CITY OF SANTA BARBARA

COUNCIL AGENDA REPORT

SUBJECT: Appeal Of The Architectural Board of Review Approval Of The Review After Final Of 336 North Milpas Street

PS1-01 SITE PLAN
SCALE: 1/20

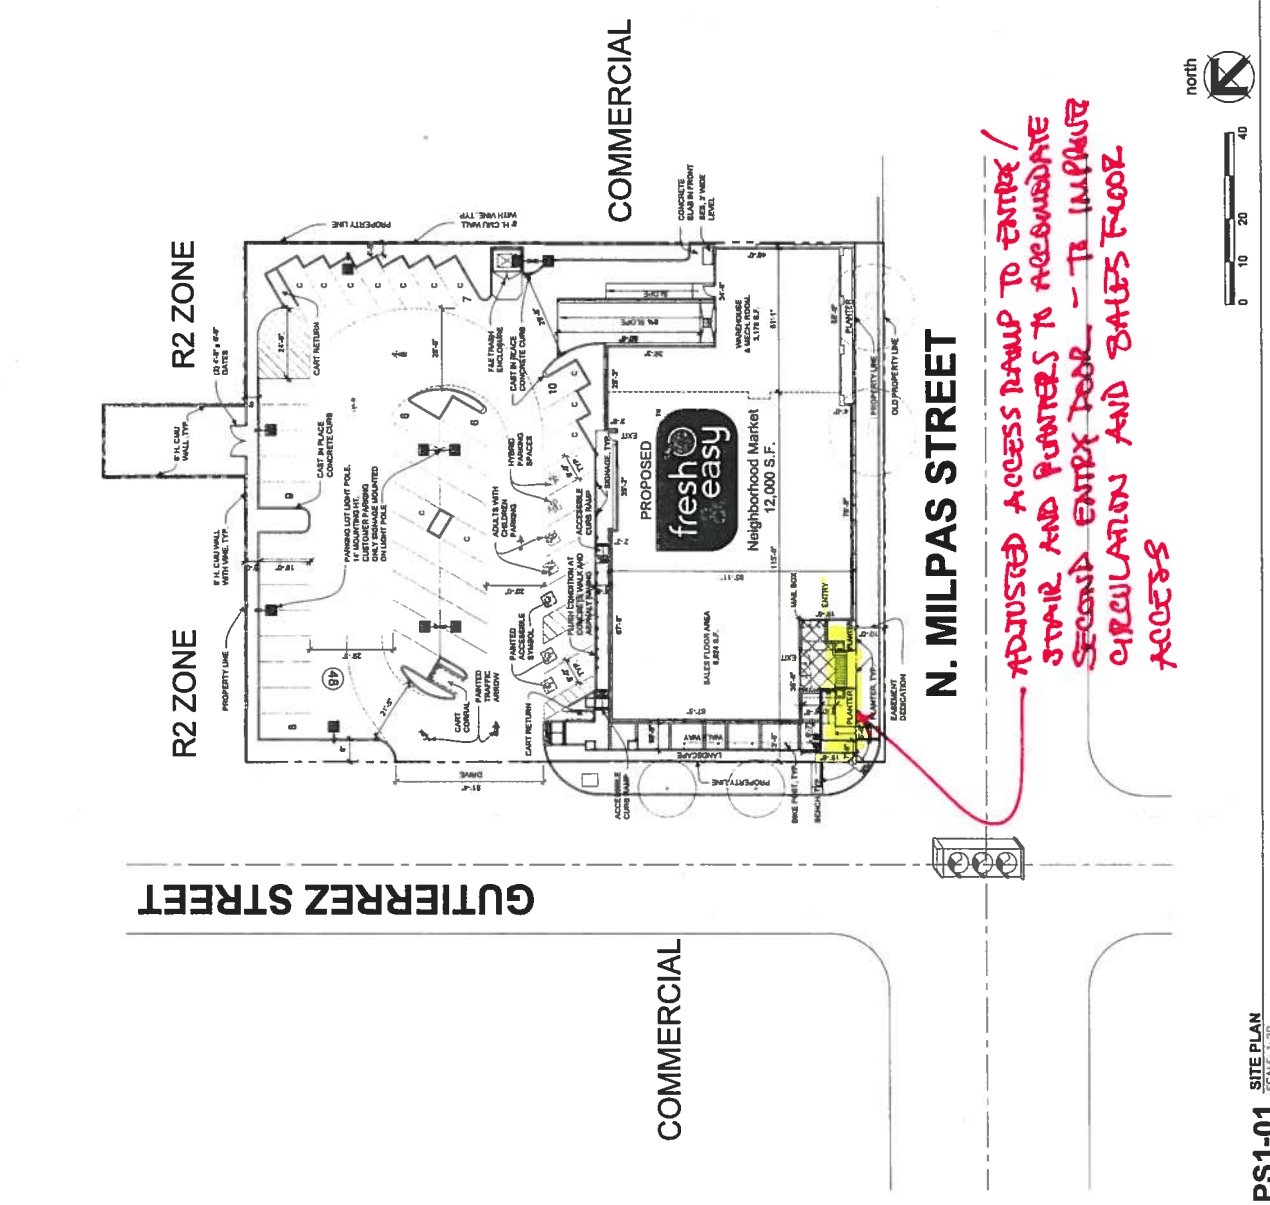
ADJUSTED ACCESS RAMP TO ENTER /
STAIR AND PLANTERS TO ADJACENT
SECOND ENTRY DOOR - TO IMPROVE
CIRCULATION AND SALES FLOOR
ACCESS

05-1 FRONT (WEST) ELEVATION
SCALE 1/8" = 1'-0"

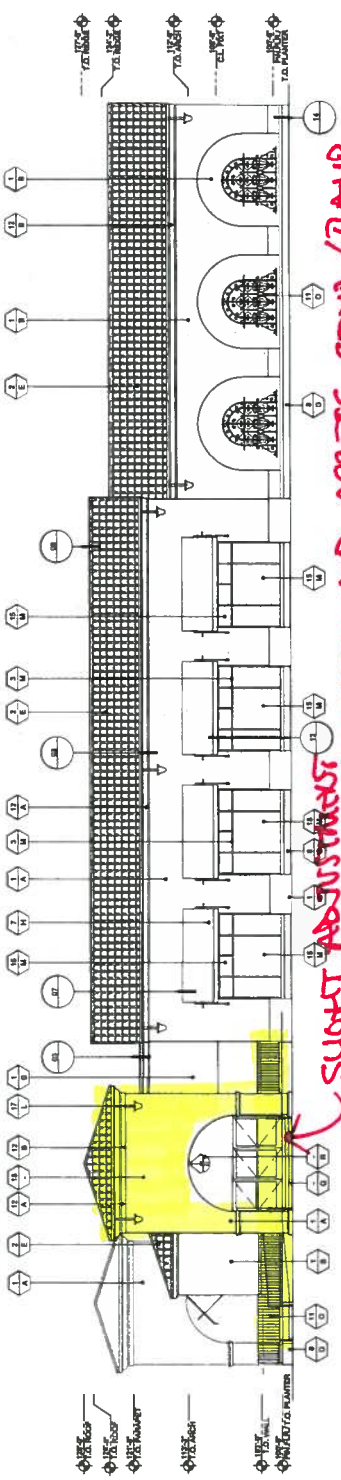
REVIEW AFTER FINAL REVISIONS
- HIGHLIGHTED FOR CLARIFICATION

05-4 RIGHT SIDE (SOUTH) ELEVATION
SCALE: 1/8" = 1'-0"

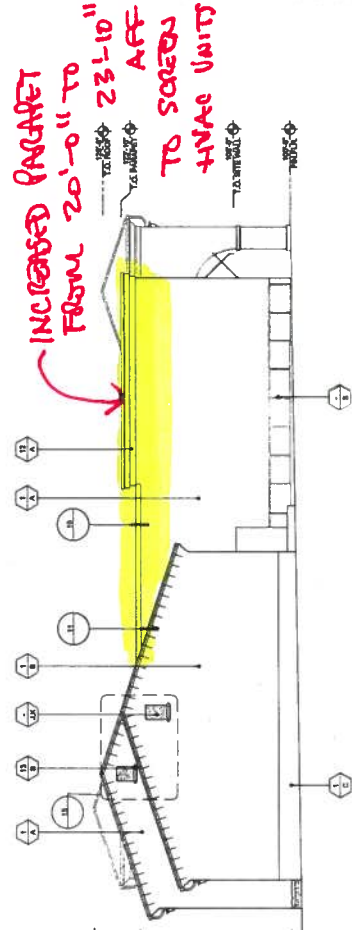
INCREASED PARAPET
FROM 20'-0" TO
23'-10" TO
AFF
TO SCREEN
THREE UNIT
